UNIVERSITY & RIDGE ADDITION WICHITA, SEDGWICK COUNTY, KANSAS

RE: SUB 2003-05 -- One-Step Final Plat of University and Ridge Addition

CASE NUMBER: SUB 2003-05 -- UNIVERSITY AND RIDGE ADDITION

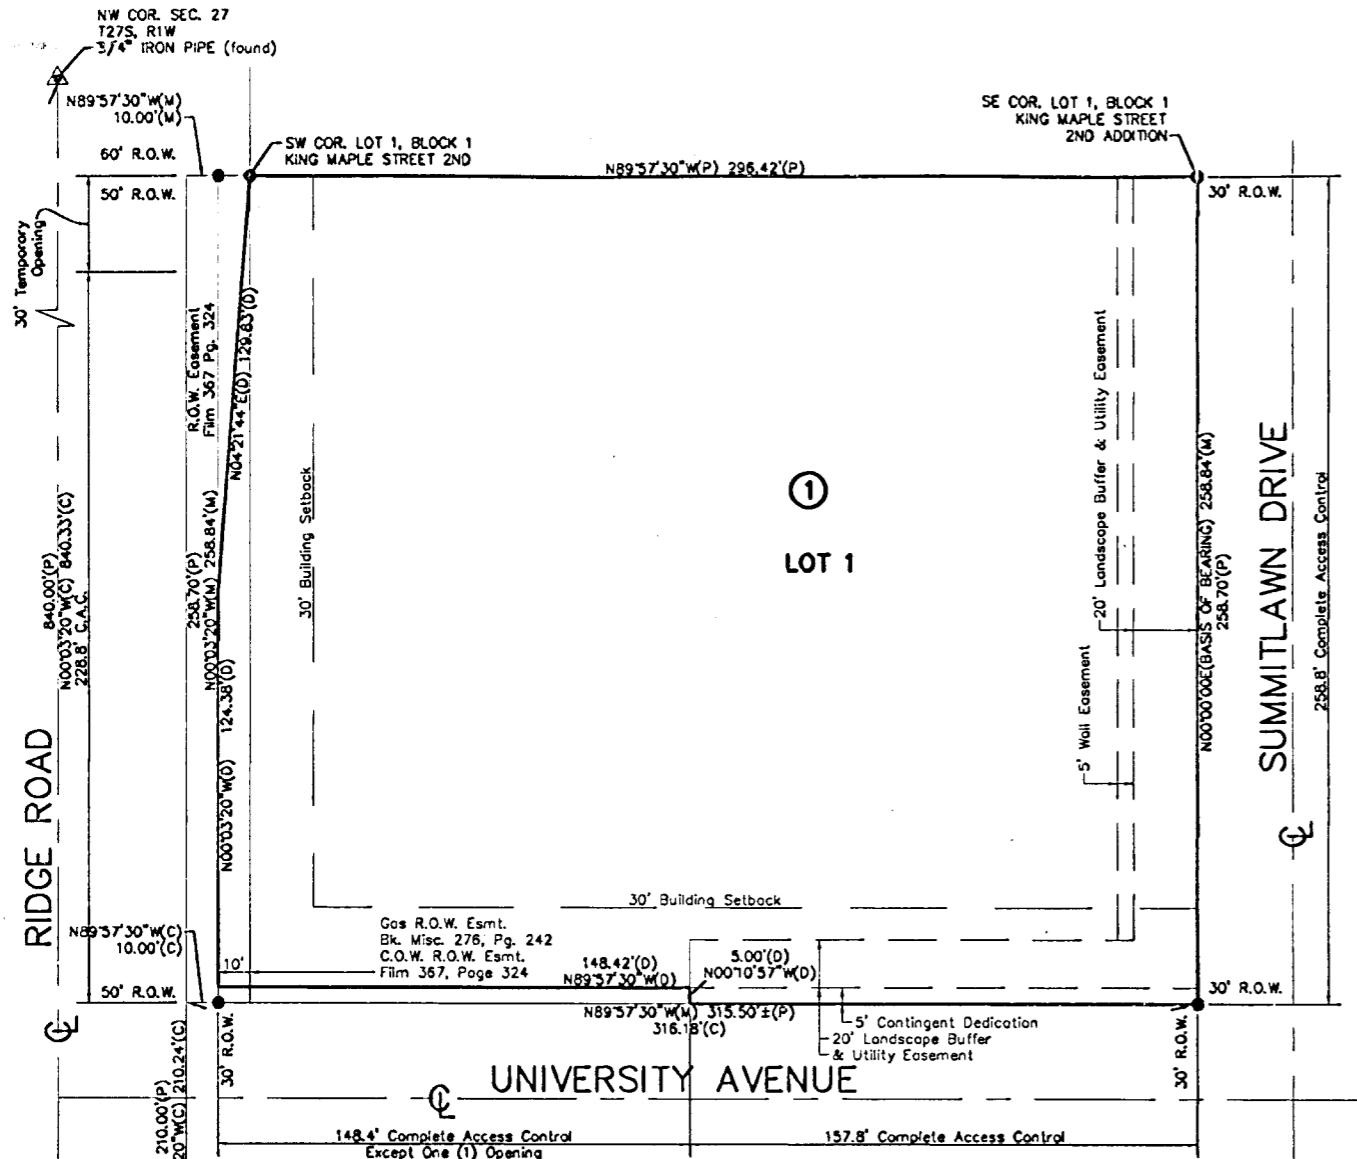
- A. Municipal services are available to serve the site.
- B. A utility easement needs to be platted for the existing sanitary sewer line and electric line.

- D. **City Engineering** needs to comment on the status of the applicant's drainage plan. **The drainage plan needs revised. A private stormwater extension will be needed at time of site development.**

- E. The plat proposes one access opening along both Ridge Road and University along with a 15-ft contingent opening along the north property line. A cross-lot access easement was approved for the property to the north (King's Maple Third Addition) through a 30-ft opening for the benefit of this property. Distances should be shown for all segments of access control. **One opening along University is approved although no left turns out are permitted. A 30-ft temporary opening along Ridge at the north property line is approved which shall be closed when an adjoining opening to the north is constructed. A cross-lot access agreement with the property to the north shall be provided that grants access rights to the owner of this plat within the west 50 feet of the property to the north.**

- F. **Traffic Engineering** has requested the dedication of 10 feet of additional right-of-way along Ridge Road to conform with the 60-ft half-street right-of-way required by the Access Management Regulations.

- G. **Traffic Engineering** has requested an additional 5 feet of right-of-way along University Avenue. The Subdivision Regulations require a 70-ft half-street right-of-way for a commercial street. **A 5-ft contingent dedication has been platted for a portion of this right-of-way which has been approved.**

- K. **County Surveying** has requested a precise location for the benchmark.
- L. The legal description needs revised to delete the language "being replatted as...".

- M. The applicant is reminded that in addition to the wall easement platted parallel to the east property line, the Protective Overlay also required a wall constructed parallel to the south property line.
